Subject: Submittal of the Response to the Notice of Disapproval for the Investigation Report for Consolidated Unit 21-018(a)-99, Material Disposal Area V, at Technical Area 21

**Response to the “Notice of Disapproval for the Investigation Report for
Consolidated Unit 21-018(a)-99, Material Disposal Area V, at Technical Area 21,
Los Alamos National Laboratory, EPA ID #NM0890010515, HWB-LANL-06-021,”
Dated January 8, 2007**

Figure 1.2-2. Proposed locations of surface and shallow-subsurface samples to be collected at Consolidated Unit 21-018(a)-99 in 2007

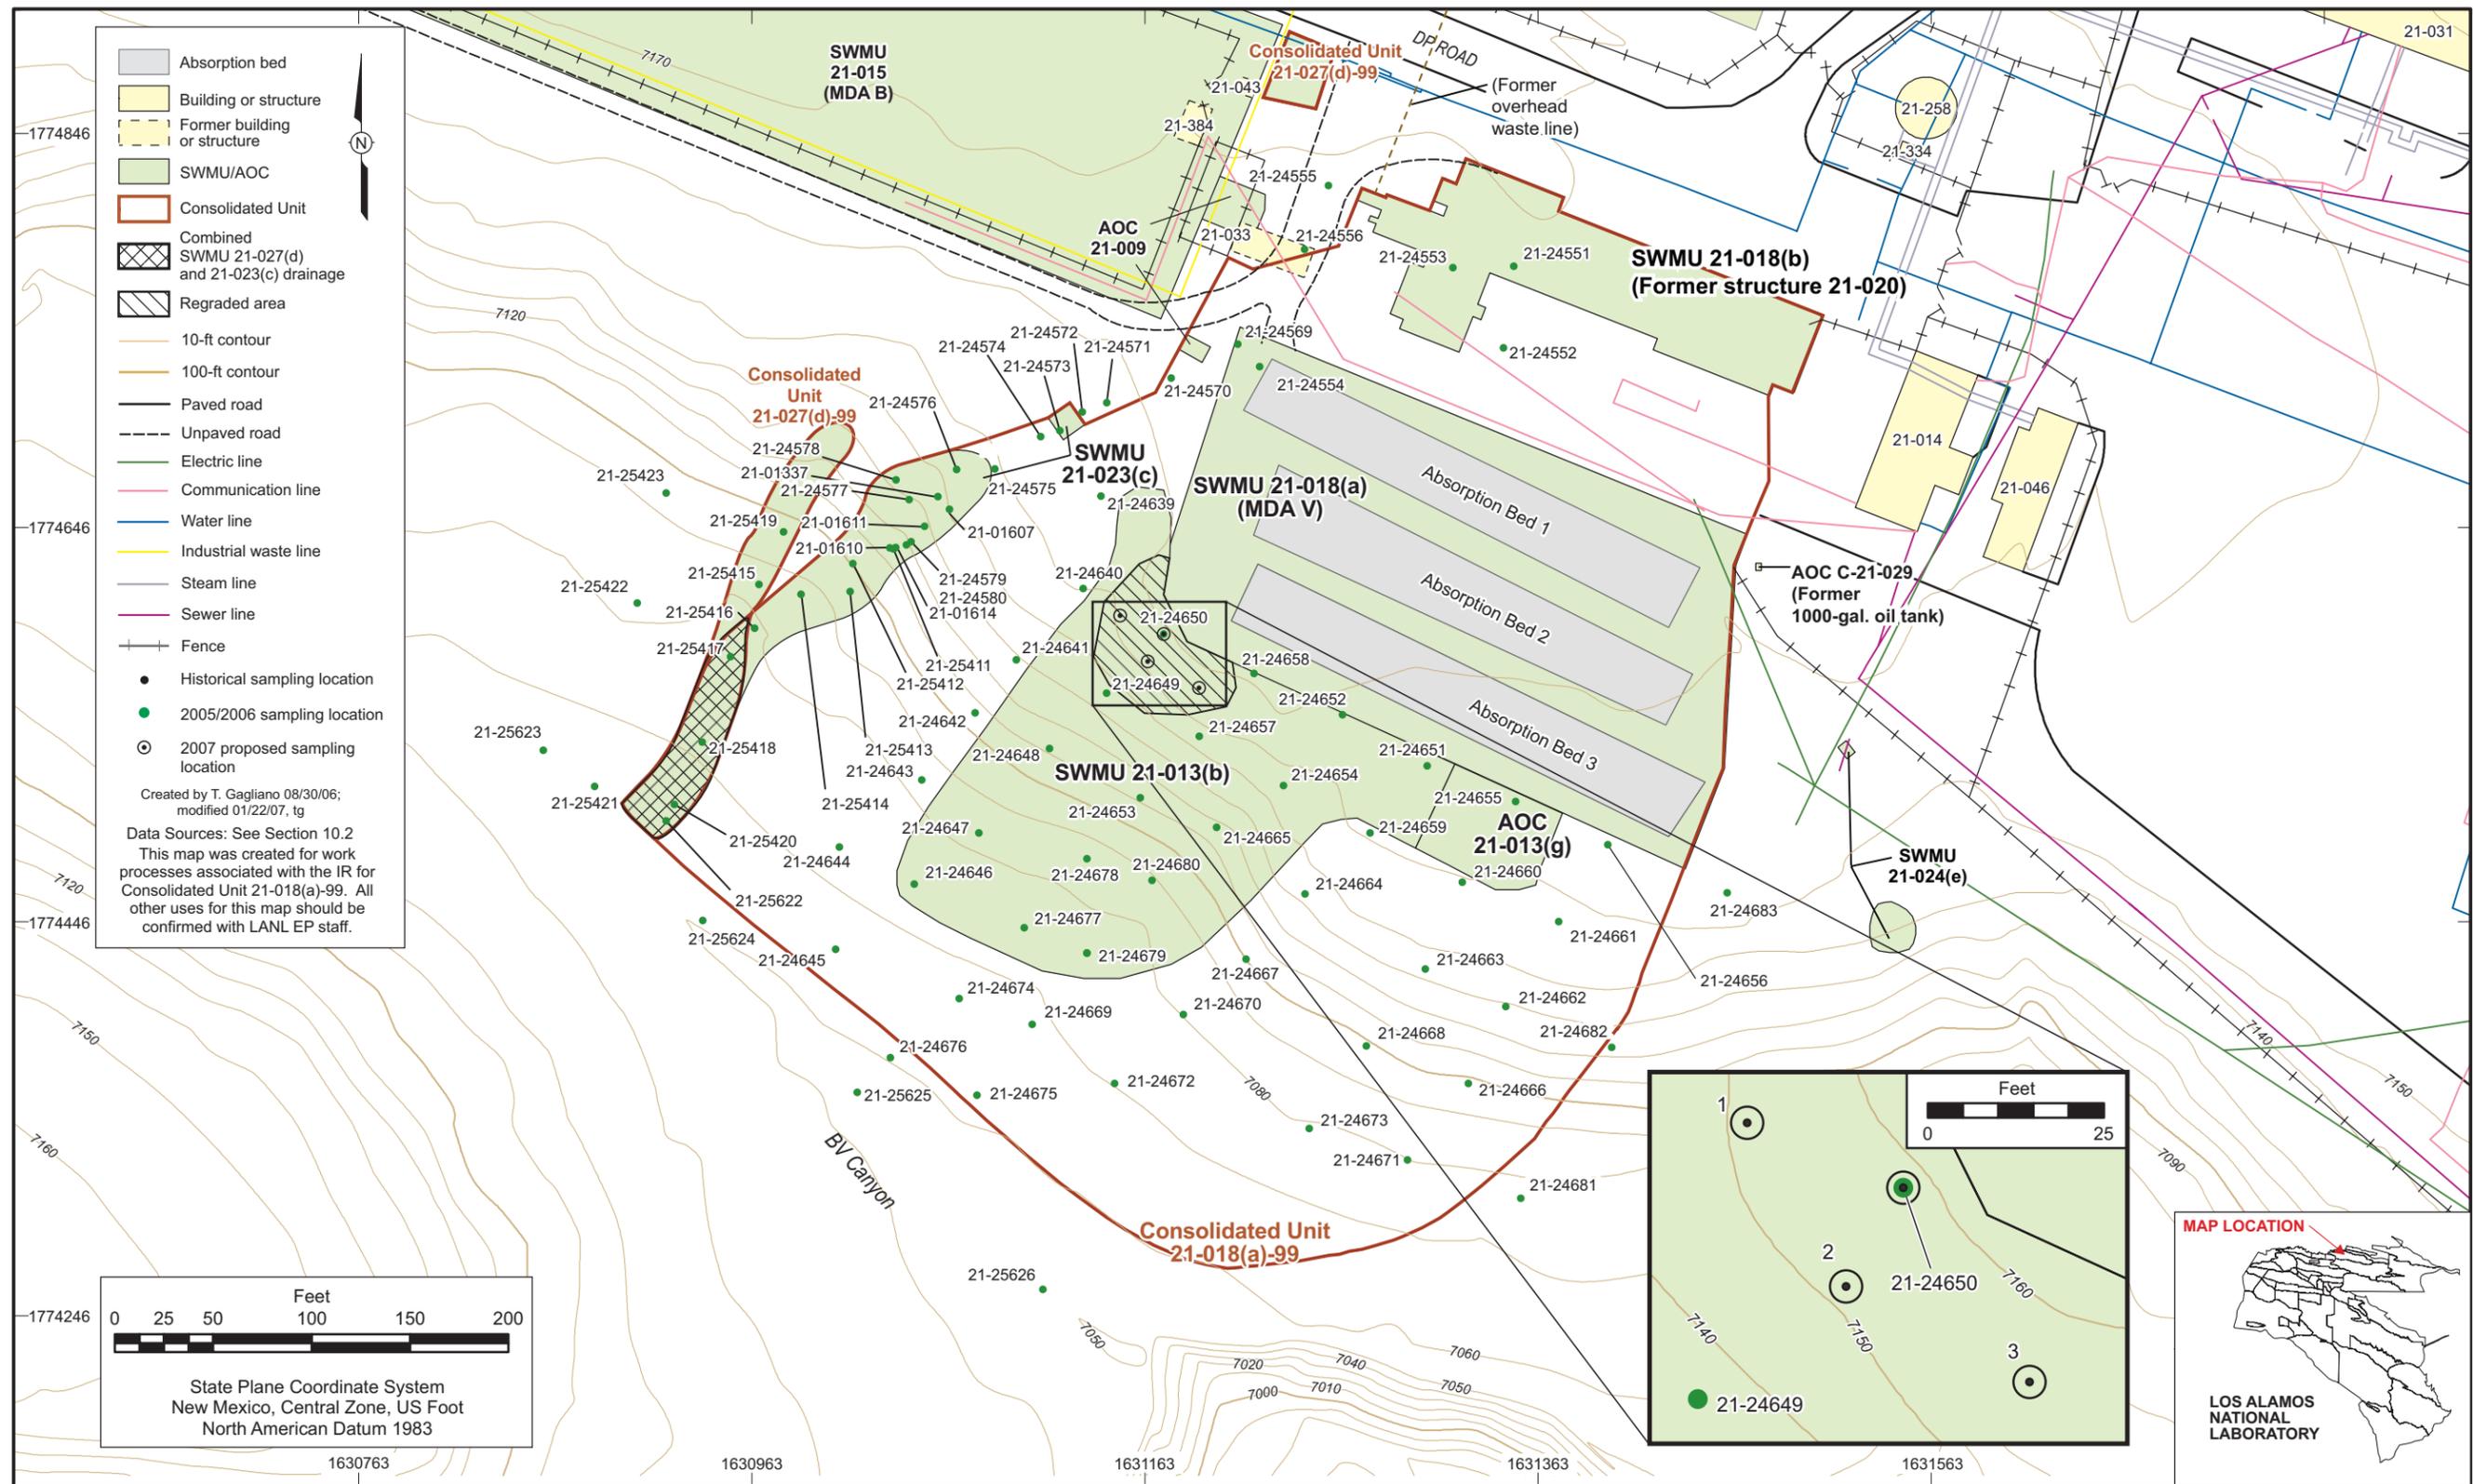
1. *The Permittees attempted to remove the soil contaminated above residential SSLs; however, the removal occurred after regrading of the slope. The Permittees did not complete any additional sampling following the removal action and therefore have no way of knowing whether the contaminated soil in question was ever actually removed. NMED cannot grant a “Corrective Action Complete Without Controls” if the residential cleanup goals were not achieved. The Permittees must complete additional surface sampling in the area where benzo(a)anthracene was originally detected to confirm that the residential SSLs have been achieved. In the response to NOD, the Permittees must propose for NMED review and approval, locations and depths for the additional sampling.*

1. Additional sampling will be performed at and around location 21-24650 to confirm the removal of benzo(a)anthracene in soil to concentrations below the NMED 2006 residential soil screening level (SSL) (NMED 2006, 92513). Additional sampling will include resampling location 21-24650 and sampling at three new locations downgradient of 21-24650 where colluvium from location 21-24650 may have been moved during slope stabilization activities. Revised Figure 1.2-2 of Attachment 1 presents proposed sampling locations, and the attachment's Table 1 summarizes the proposed sampling depths. All samples will be analyzed for semivolatile organic compounds (SVOCs) using U.S. Environmental Protection Agency (EPA) Method 8270. The results of the additional sampling will be included in the revised investigation report.
